**V2500-A5 SERIES PROPULSION SYSTEMS SERVICE BULLETIN**

This document transmits the Initial Issue of Service Bulletin EV2500-71-0148

**V2500-ENG-71-0148**

ENGINE – POWERPLANT – MODIFICATION OF THE EEC HARNESS SUPPORT BRACKET

Rework of harness support bracket  
Fig 1

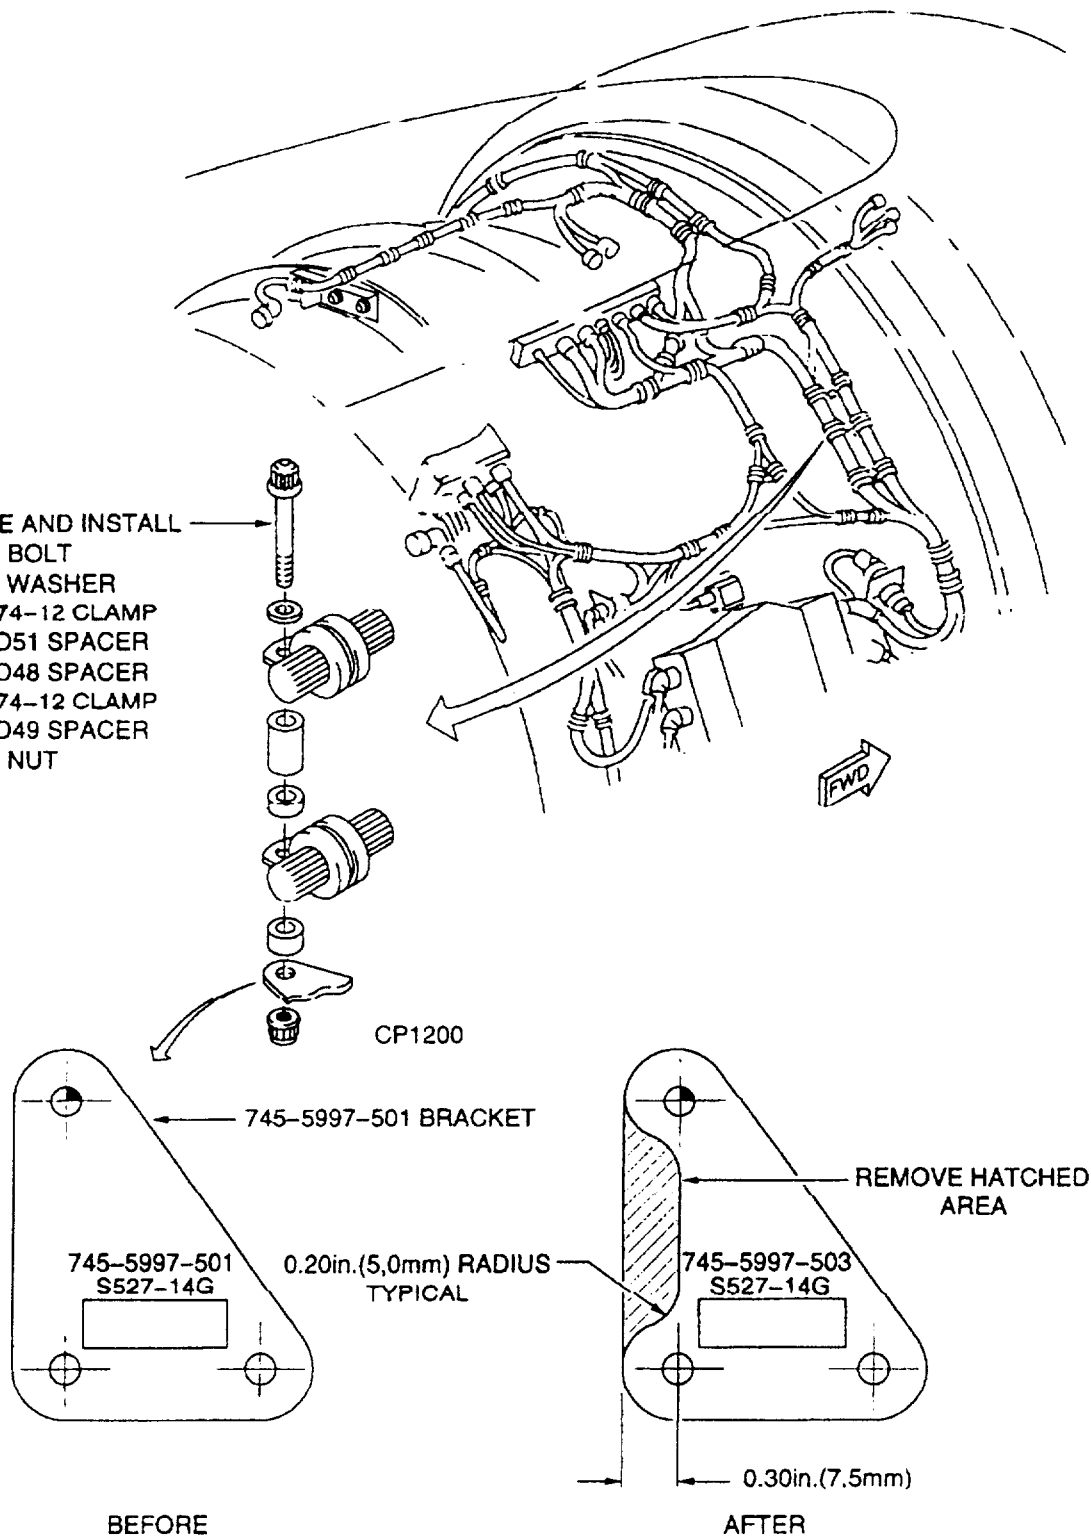
Insufficient clearance may exist between a support bracket for the EEC harness and an adjacent bracket at clipping position CP1200

This condition has been observed during assembly of production engines. A review of the existing installation has shown the need to rework the support bracket to obtain the necessary clearance

The existing bracket which supports clipping point CP1200 is removed and modified to the new configuration (refer to Fig 1)

- (1) Trim the bracket 745-5997-501 as shown (Refer to Fig 1)
- (2) Use a file and remove any sharp corners or burrs
- (3) Identify the bracket to the new part number as shown with ink (CoMat 06-073) and a rubber stamp. Refer to IAE V2500 Standard Practices/Processes Manual, Chapter 70-09-00.
- (4) Install the bracket 745-5997-503 on the FA engine flange with two 4W0002 nuts and two AS21516 bolts as shown. Torque the bolts to 63 to 70 lbfin (7 to 8 Nm). Refer to the A320/A321 Aircraft Maintenance Manual, 70-23-11 on torque tightening techniques
- (5) Install clipping point CP1200 on the bracket 745-5997-503 as shown, with a 4W0132 bolt, SP154D washer, two TA025074-12 clamps, ST1698D51 spacer, ST1698D48 spacer, ST1698D-49 spacer and a 4W0001 nut. Torque the bolts to 20 to 25 lbfin (2 to 3 Nm). Refer to the A320/A321 Aircraft Maintenance Manual, 70-23-11 on torque tightening techniques

REMOVE AND INSTALL  
4W0132 BOLT  
SP154D WASHER  
TA025074-12 CLAMP  
ST1698D51 SPACER  
ST1698D48 SPACER  
TA025074-12 CLAMP  
ST1698D49 SPACER  
4W0001 NUT
